APPLICATION NO.	FILING DATE	FIRST NAMED INVENTOR	ATTORNEY DOCKET NO.	CONFIRMATION NO.
10/551,850	11/27/2006	Rune Haug	037960.002	6186
7590	11/12/2009		EXAMINER	
James E Bradley Bracewell & Giuliani P O Box 61389 Houston, TX 77208-1389			EVANS, EBONY E	
		ART UNIT	PAPER NUMBER	
		3644		
		MAIL DATE	DELIVERY MODE	
		11/12/2009	PAPER

Office Action Summary	Application No.	Applicant(s)	
	10/551,850	HAUG, RUNE	
	Examiner	Art Unit	
	EBONY EVANS	3644

DETAILED ACTION

FIG. 1A

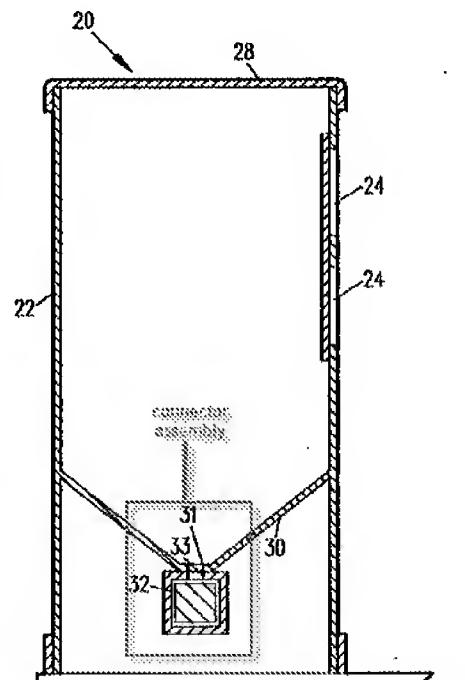
3. In re to claim 1, Huddleston '802 disclose a device for distributing fish feed to multiple fish receptacles in a fish fanning plant comprising: at least one fish feed tank (23) having a plurality of outlets (fig. 1a); an individually controllable pump (90) arranged at each of the outlets for fish feed; and a conduit (54) extending from each of the pumps, each of the conduits being connected to a connector assembly (fig. 3) at the exterior (fig. 3) of the device, for communicating with each fish receptacle.

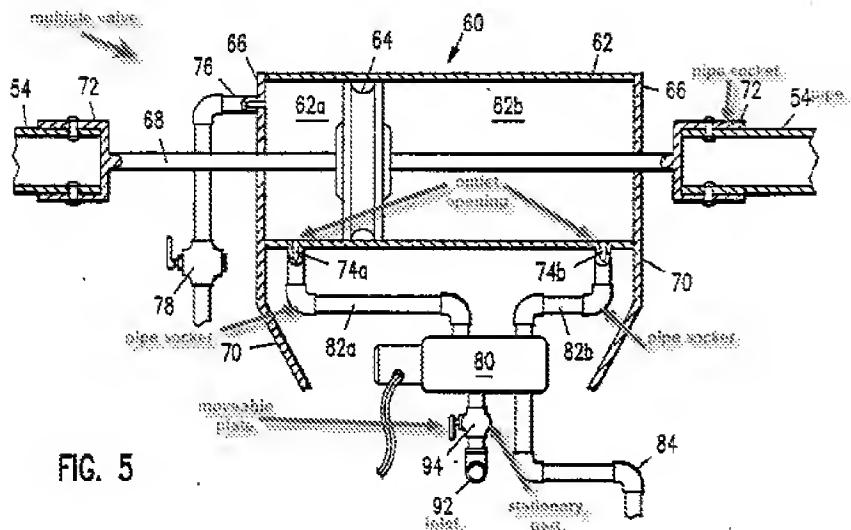
5. In re to claim 3, Huddleston '802 disclose the device according to claim 1, further comprising: a multiple valve (80) having a stationary part (94) with at least two parallel rows of outlet openings (fig. 5) and a movable part (95) with a row of inlet openings, the moveable part (95) being movable between an open and a closed position relative to the openings in the stationary part (col. 10, lines 67-68);

- the rows of outlet openings being perpendicular to the direction of movement of the moveable part (fig. 5), each outlet opening (74a and 74b) having a pipe socket for connection to a conduit supplying fish feed to a fish receptacle; and

- the movable part being a plate containing the row of inlet openings that corresponds with the rows of outlet openings (74a, 74b), the movable plate being arranged for the rows of outlet openings being perpendicular to the direction of movement of the moveable part, each outlet opening having a pipe socket for connection to a conduit supplying fish feed to a fish receptacle, and

- the movable part (fig. 5) being a plate containing the row of inlet openings (92) that corresponds with the rows of outlet openings (74a,74b), the movable plate being arranged for sliding movement on the stationary part (fig.5) between a position wherein one of the rows of outlet openings is aligned with the corresponding openings in the row of inlet openings, and a position in which the openings in the other row of outlet openings are aligned with the corresponding openings in the row of inlet openings (fig. 5, inlet and outlet openings are parallel, therefore they are aligned).

6. In re to claim 4, Huddleston '802 discloses the device according to claims 3, wherein each of the inlet openings (92) has a tube pipe socket, each tube pipe socket being connected to one of the conduits leading to one of the pumps (fig. 5).
